## **Response to Comment Letter L1**

**RE: SJFD Response to BART Phase II Draft EIS/EIR**

**RE: City of San José's Comment Letter relating to the VTA's BART Silicon Valley Phase II Extension Project Draft Supplemental EIS/Subsequent EIR, December 2016**

SILICON VALLEY SANTA CLARA EXTENSION  
 NEWHALL MAINTENANCE FACILITY & TAIL TRACK  
 PLAN SHEET 14

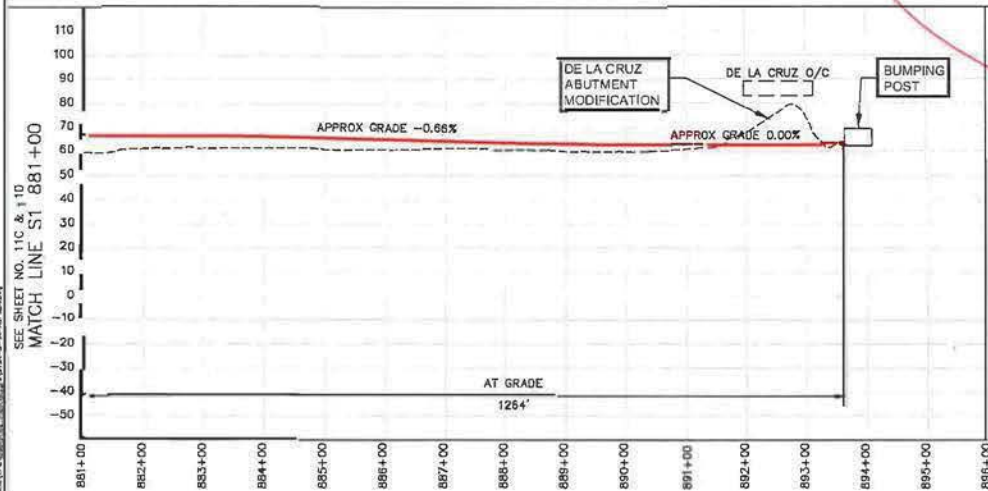
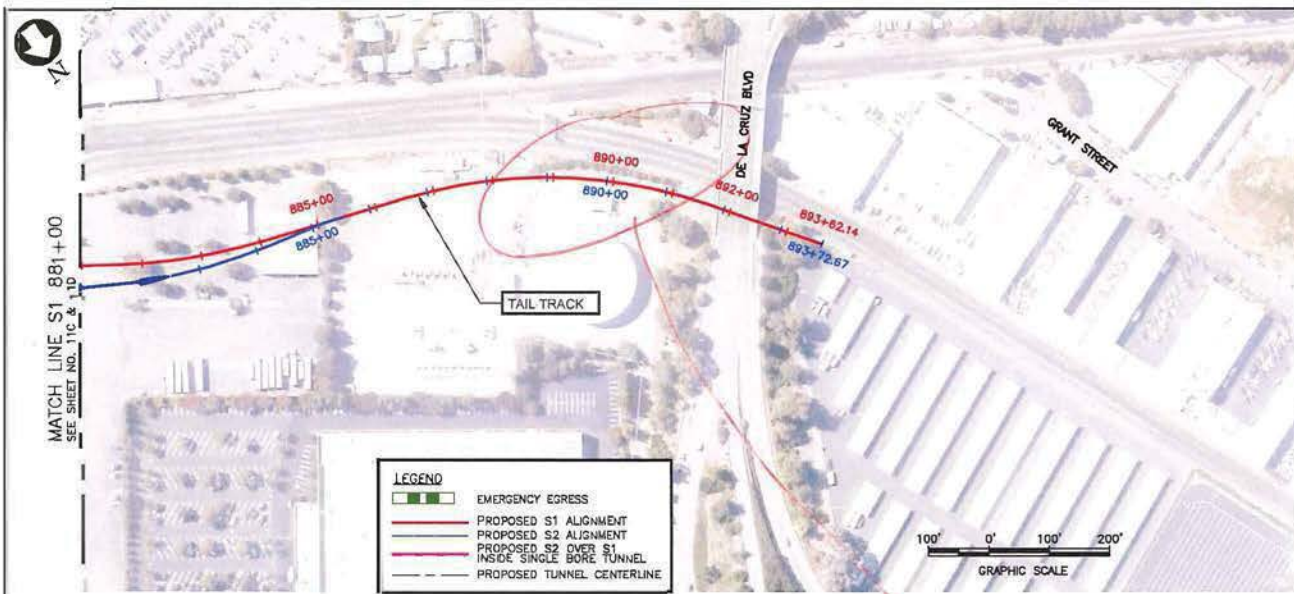
These tracks are on the pump house in this location  
 - show the bow line and location of perimeter fence  
 - tracks are too close to tank and well  
 - tracks obstruct the access road  
 S.D. around the tank

Figure 5-10

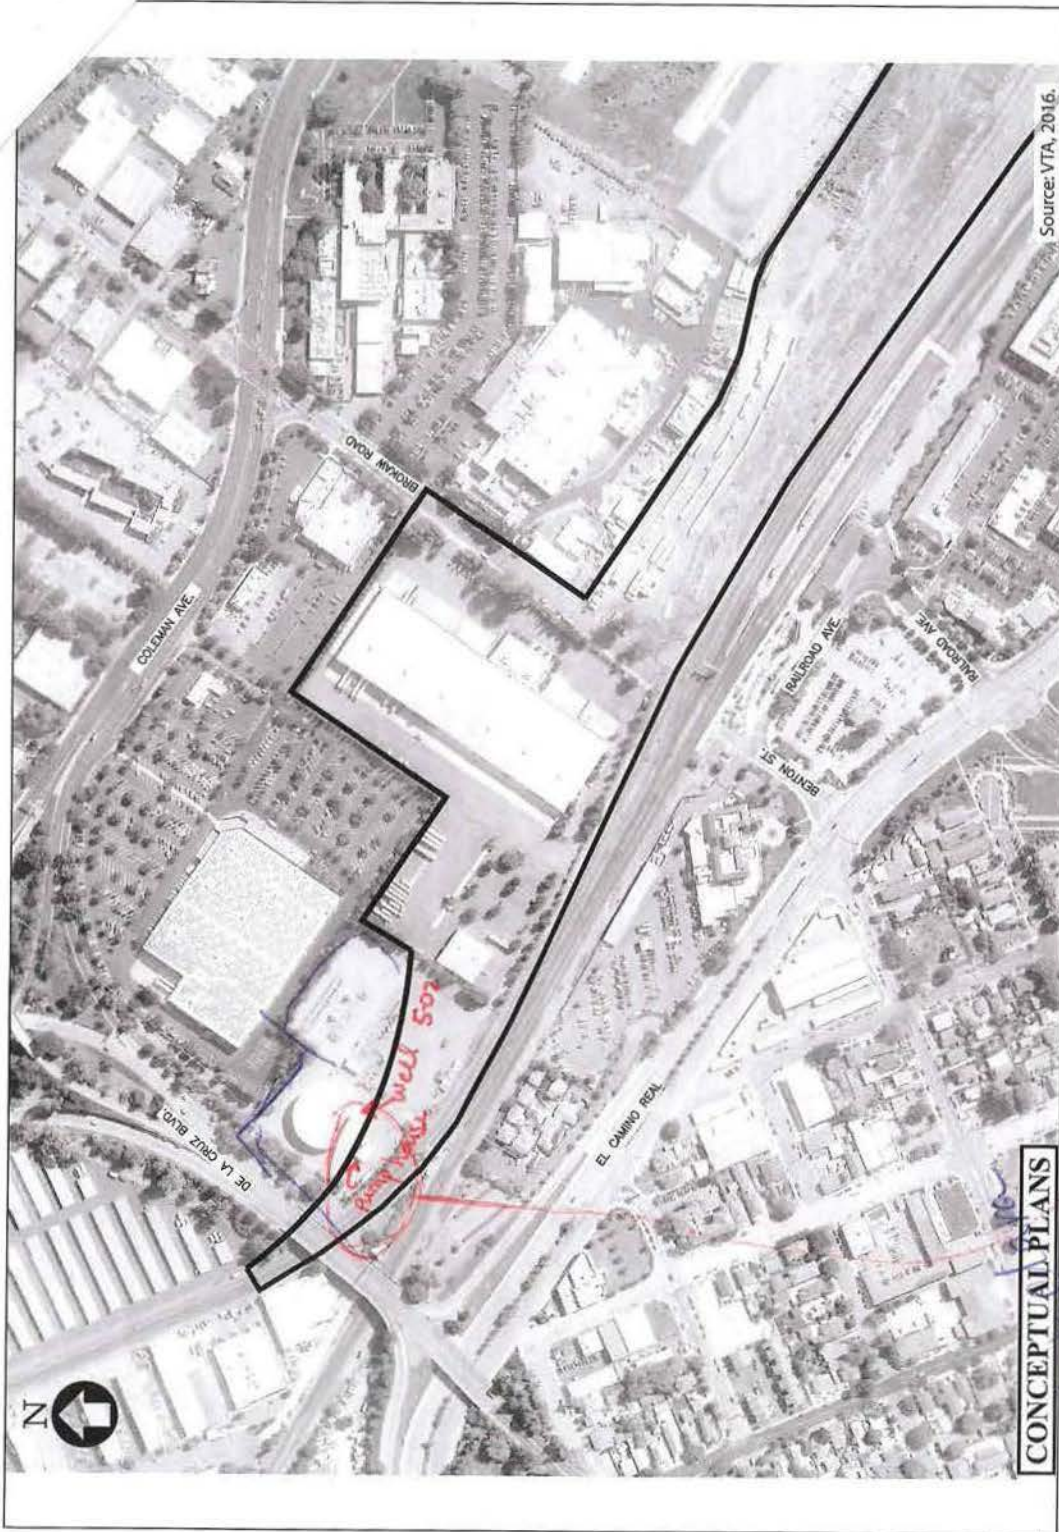
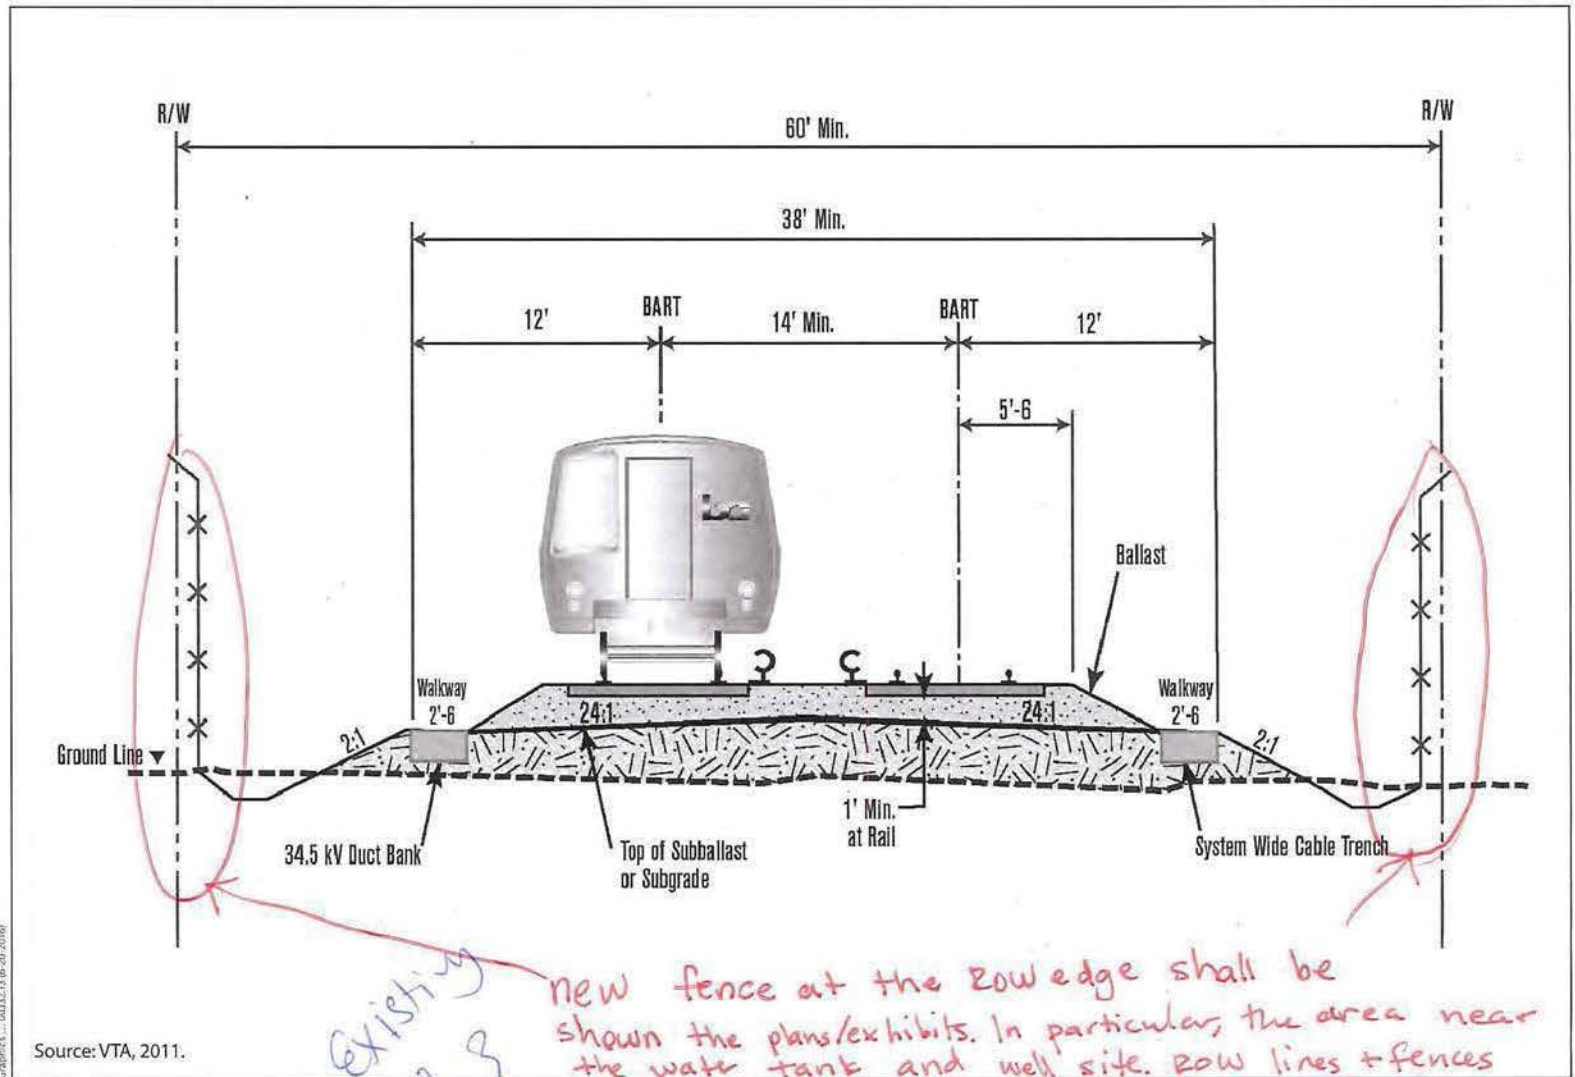
35. In Figure 5-10, there is an active water well within the staging area. Demolishing this well and its associated structure would not be permitted by the City. There is also a water storage tank adjacent to the staging area outline. Revise this section of the EIR to maintain 25' clear from the water pump house/structure, Well 5-02, and the transformer pad. Show the well and the transformer pad in the conceptual plans. | L4-35

*Staging area cannot be on the water pump house/structure, well 5-02, and transformer pad. Maintain 25' clear. Show well and transformer pad.*

L4-35 See responses to comments L4-19 and L4-25. Construction staging areas shown in Figure 5-10, *Proposed Santa Clara Construction Staging Area*, may be further refined during the design and engineering phase in consultation with the City of Santa Clara.

**Figure 5-23**  
**At-Grade Guideway**  
 VTA's BART Silicon Valley-Phase II Extension Project

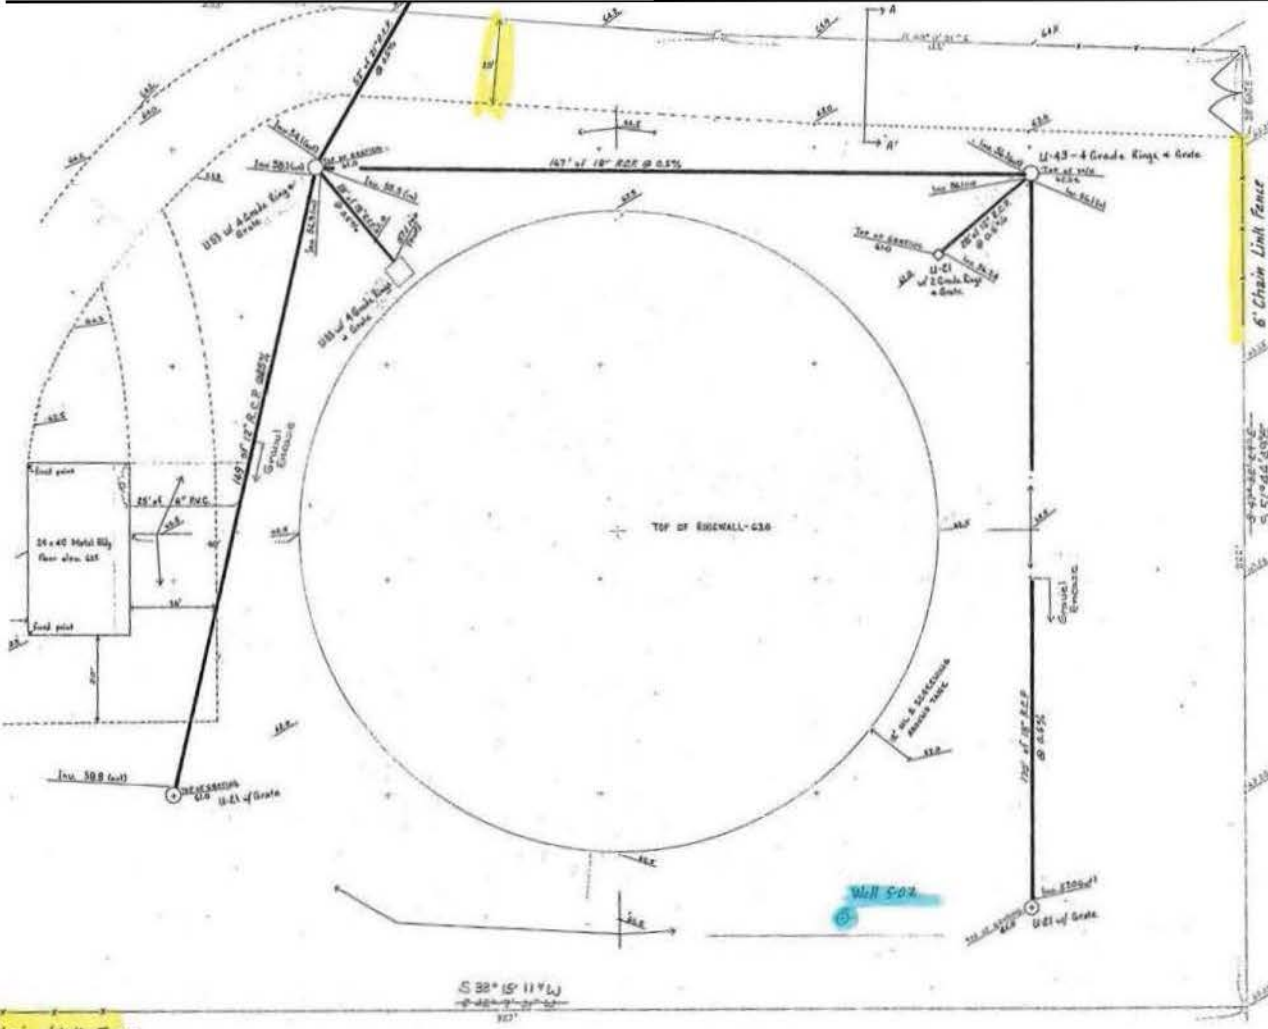
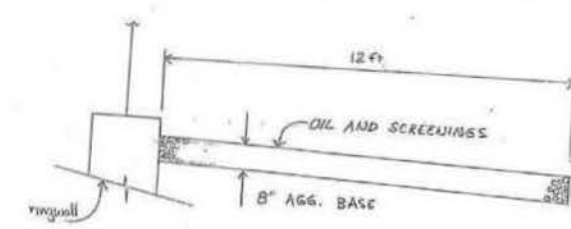
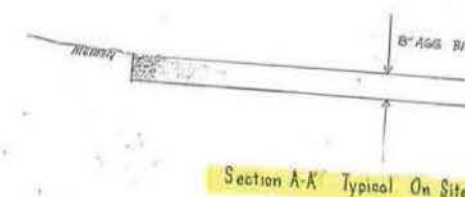
37. In Figure 5-23 and other relevant plans and exhibits, show the proposed fencing at the edge of the BART R-o-W. In particular, separations between the water tank and well sites and the proposed R-o-W and fencing shall be clearly shown. | L4-37

new fence at the Row edge shall be shown the plans/exhibits. In particular, the area near the water tank and well site. Row lines + fences shall be clearly marked/shown
